SECTION 009113 – ADDENDUM TWO

- A. Project Name: 22075 Forest Elementary Playground
- B. Owner: Forest Municipal School District
- C. Architect: Dale Partners Architects, P.A.
- D. Architect Project Number: 22075
- E. Date of Addendum Two: 5 January 2023

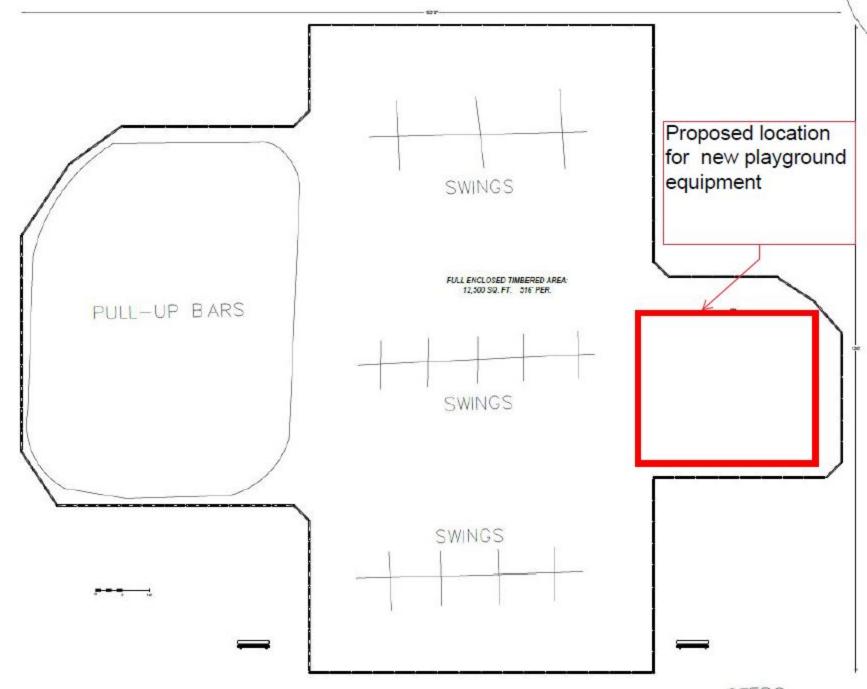
D. <u>QUESTION</u>: Are you able to show on Google Earth where the new equipment is to be placed?

ANSWER: See Attachment
